**MILTON MUNICIPAL UTILITY COMMISSION
CABELL COUNTY, WEST VIRGINIA**

**CONTRACT #2 – SANITARY SEWER REHABILITATION AND LIFT STATION
RELOCATION**

ADDENDUM #1

FEBRUARY 1, 2022

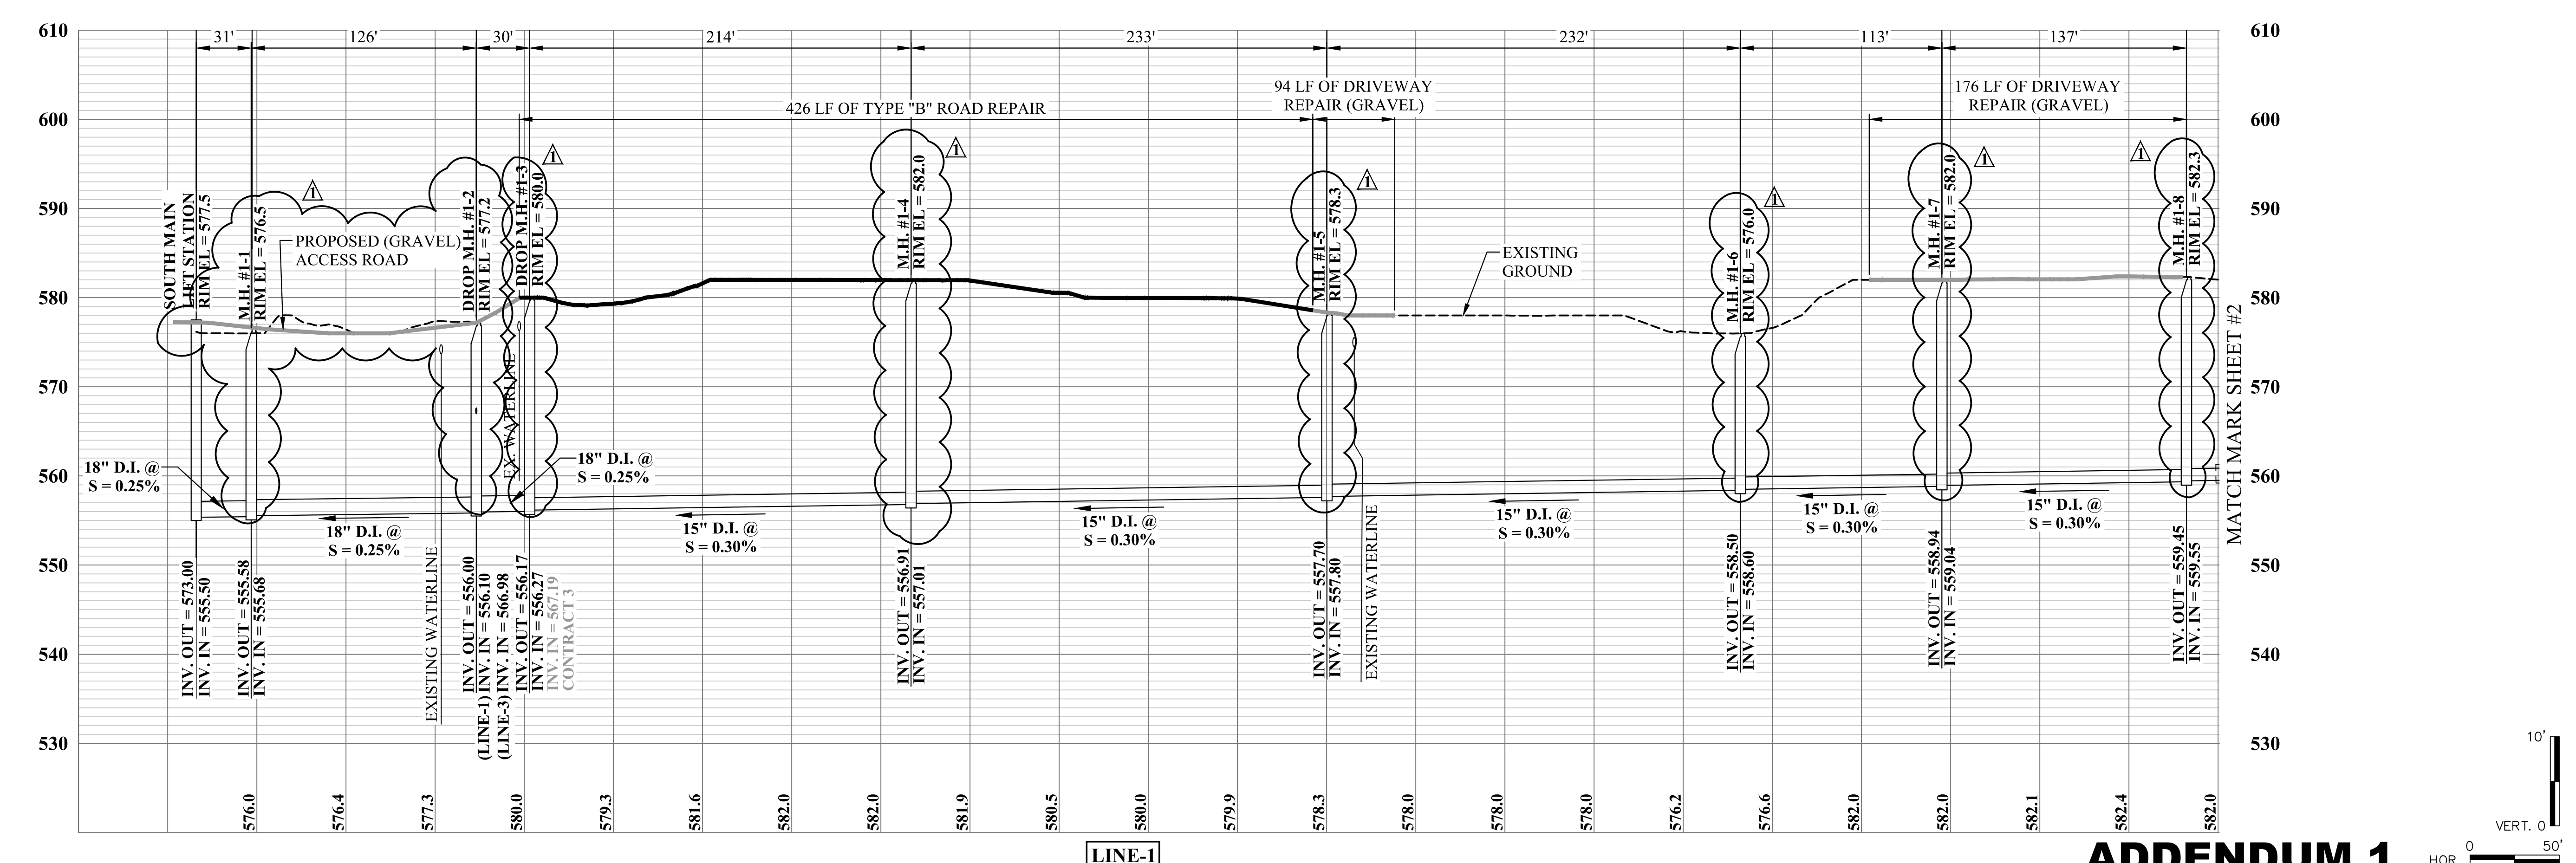
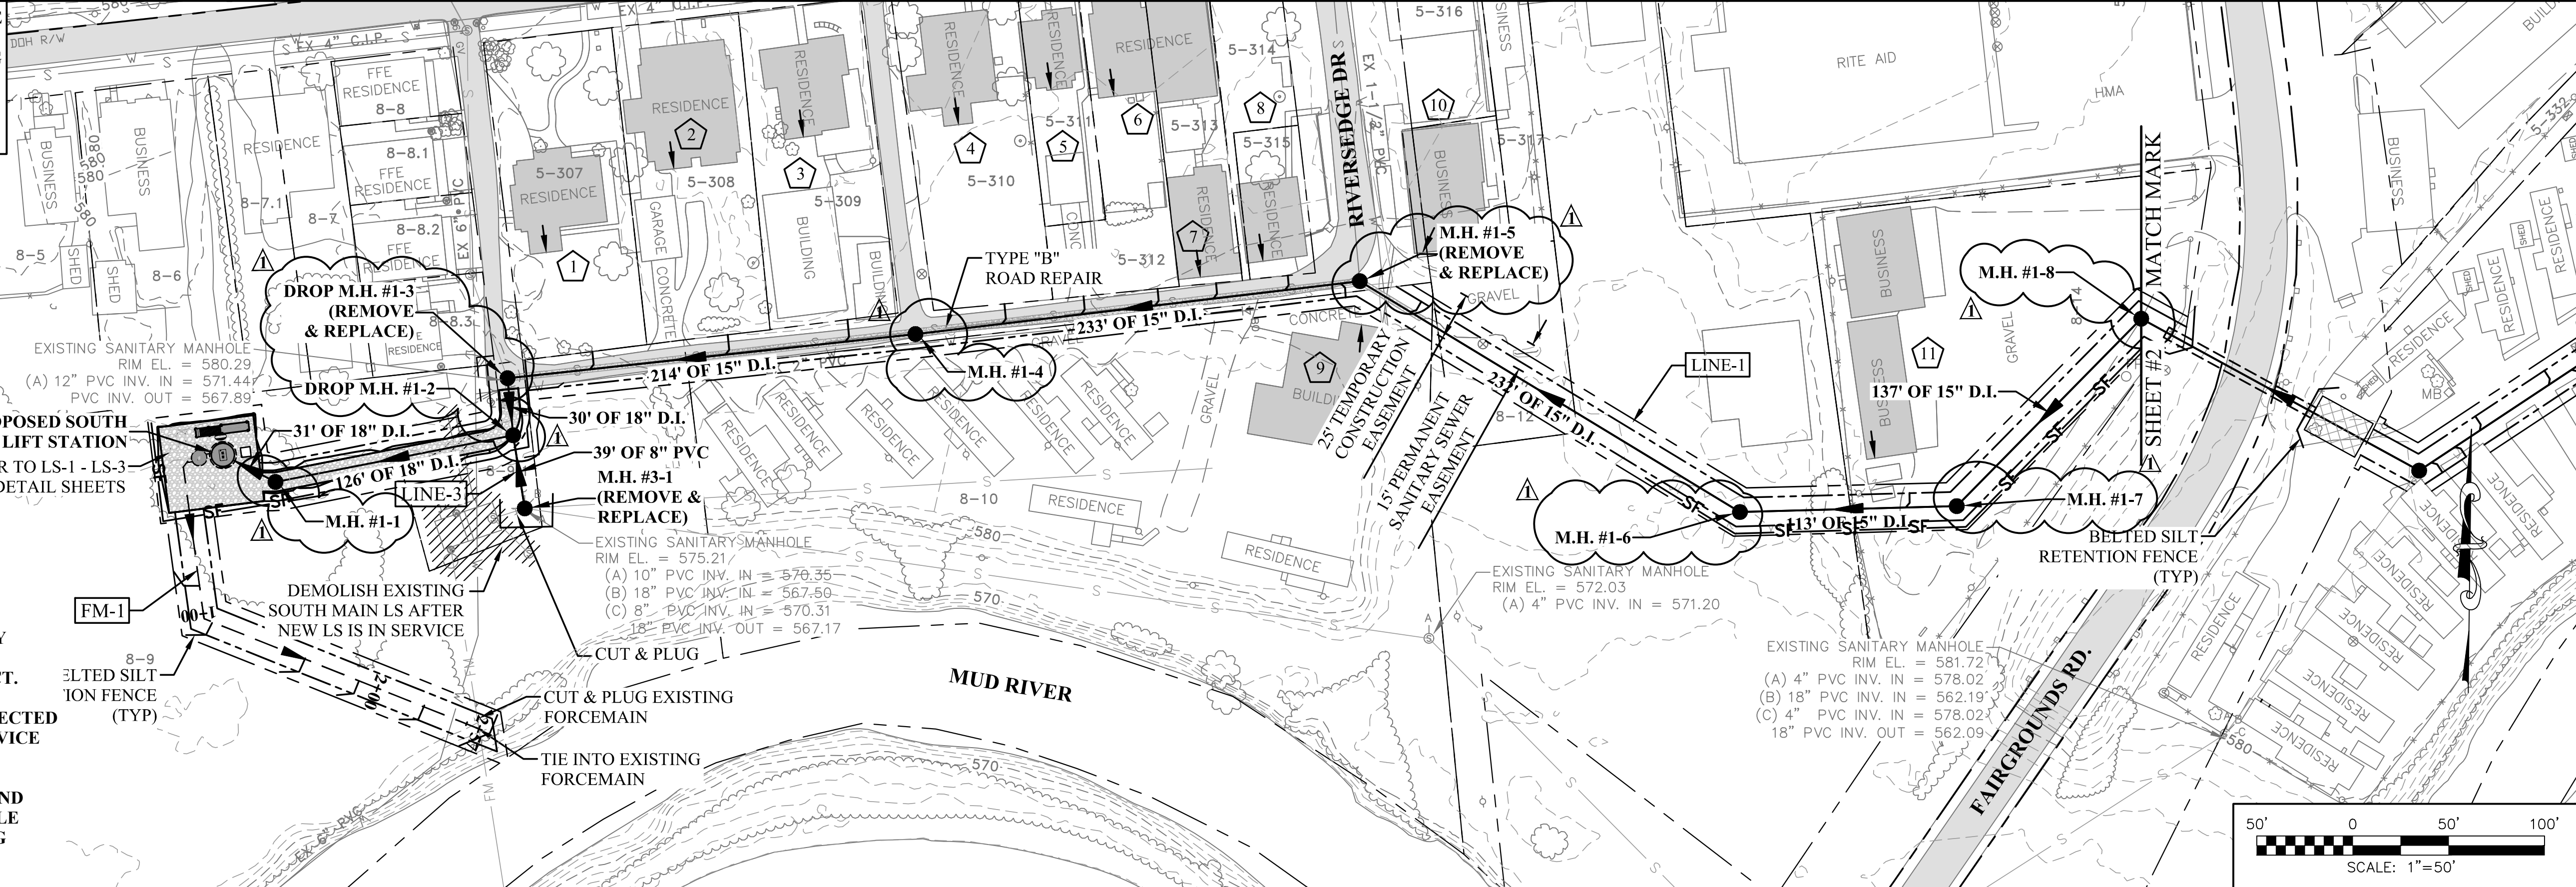
NO.	BY	DATE	DESCRIPTION
1	KMP	1/2022	ADDENDUM 1 - UPSIZED MANHOLES TO 60" - REVISED GRADING
